Response to February 3, 2005 Office Action and
June 6, 2005 Notice of Non-Compliant Amendment

Amendments for the Figures

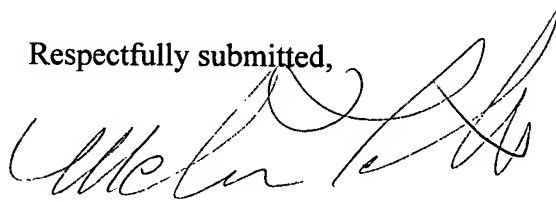
Appended here is Replacement Sheet Figure 1, which amends Figure 1 as requested by the Examiner to point out a recess for a gas lever 22.

The Examiner objected to the drawings as failing to show every feature of the invention specified in the claims. Specifically, the Examiner is requested that we point out and label in the drawings the smaller tank shell (cited in claim 17) and the recess for a gas lever (cited in claim 23). Regarding the smaller tank shell, as indicated on page 4,

Regarding the recess for a gas lever, we have amended the specification and Figure 1 to indicate this as requested by the Examiner.
